**STATUS OF FEMP WASTEWATER TREATMENT UNITS AS SWMUS OR  
HWMUS - (USED AS A REFERENCE IN OU1 RI)**

**C:OP:93-0737  
DOE/FERMCO    OEPA  
28  
LETTER**

**STATUS OF FEMP WASTEWATER TREATMENT UNITS AS SWMUs OR HWMUs**

ENCLOSURE 2  
RESPONSE TO SPECIFIC OEPA COMMENTS ON THE DRAFT REPORT ON FEMP'S WWTS

6330

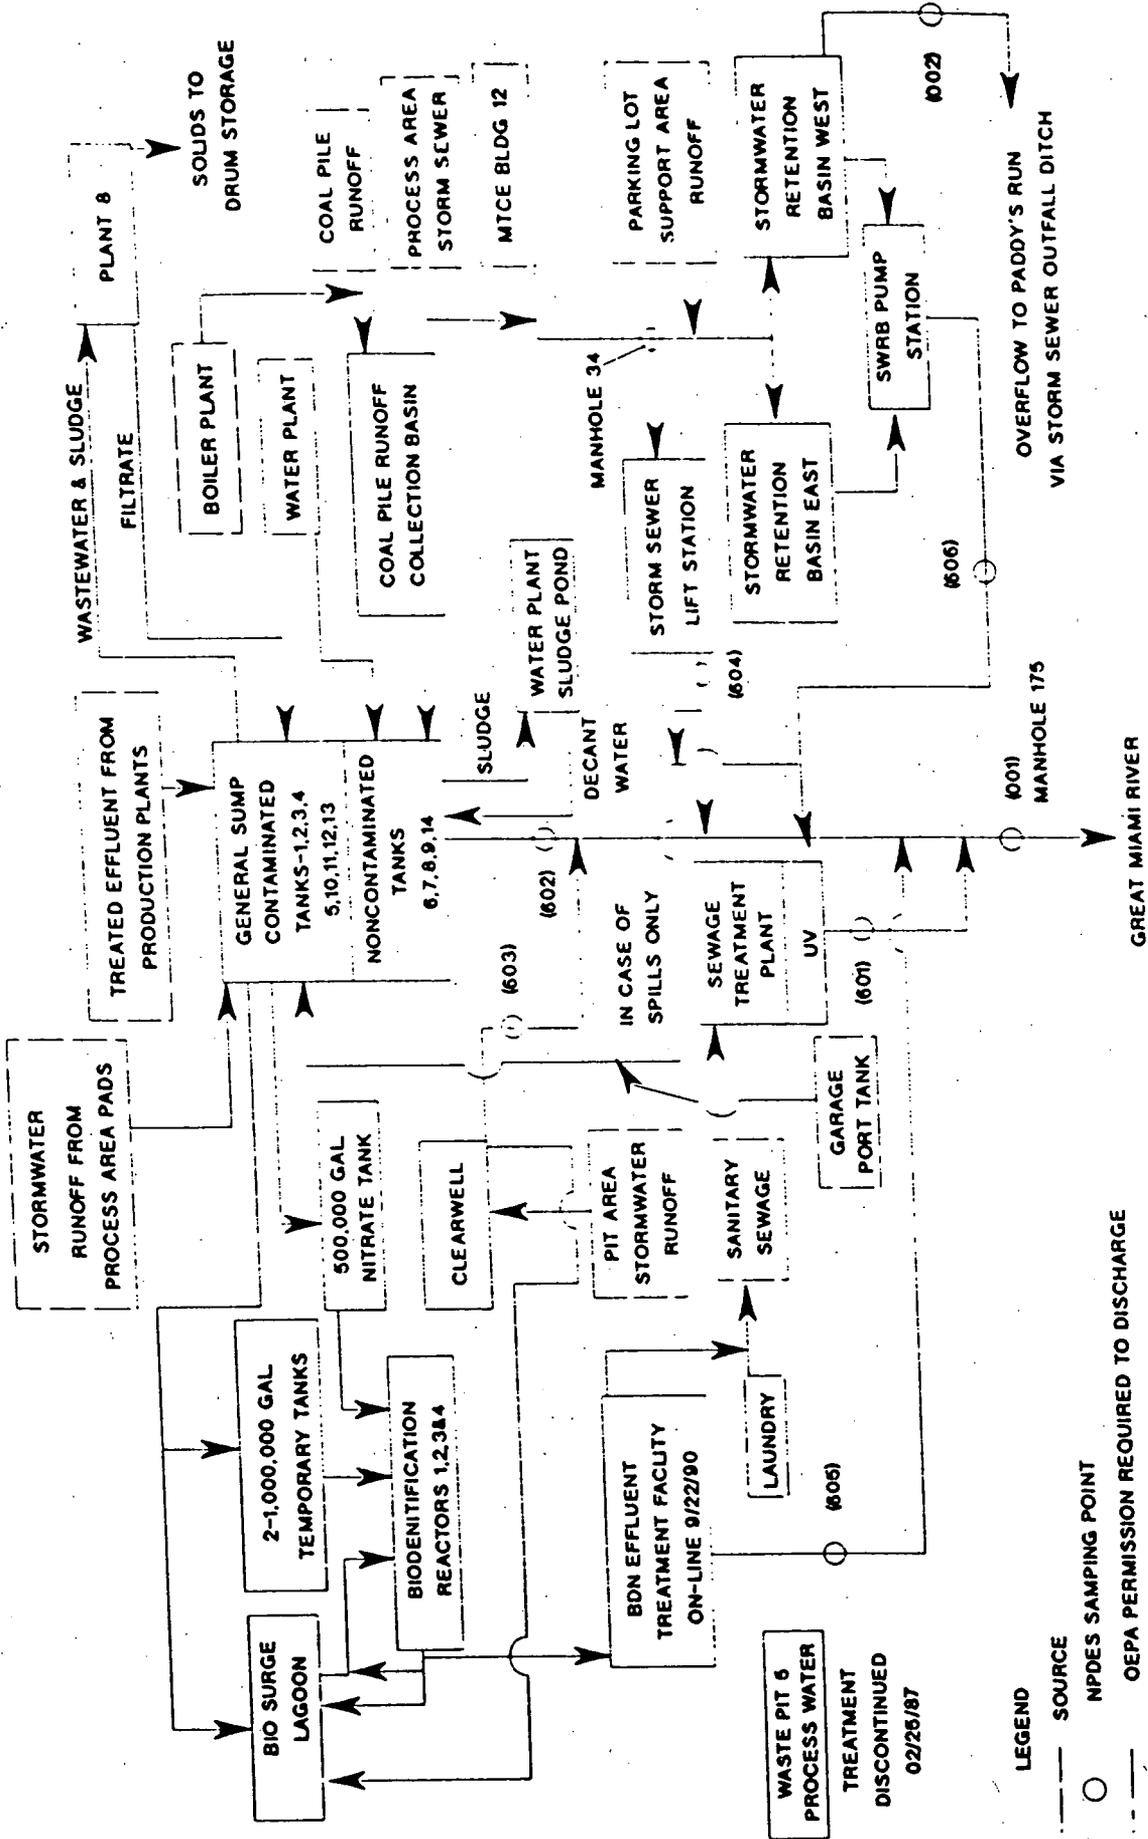
1. *Ohio EPA requests all documentation which exists to support the numbers used for wastewater flow in the 9/5/91 report for the NGS headworks calculations. Indicate any and all locations at which this flow was measured.*

The final wastewater mixture rule exclusion report uses the National Pollutant Discharge Elimination System (NPDES) Discharge Monitoring Report (DMR) data for all flows used in the calculations. The NPDES permit requires flow measurement at the final outfall 001 and the internal outfalls:

- Sanitary System - Sampling Point 601
- Noncontaminated General Sump - Sampling Point 602
- Contaminated General Sump - Sampling Point 603 (prior to 1987)
- Stormwater System - Sampling Point 604

The block flow diagrams in Attachment 1 show the location of these sampling points. A summary of the data is provided in Table 4 of the report.
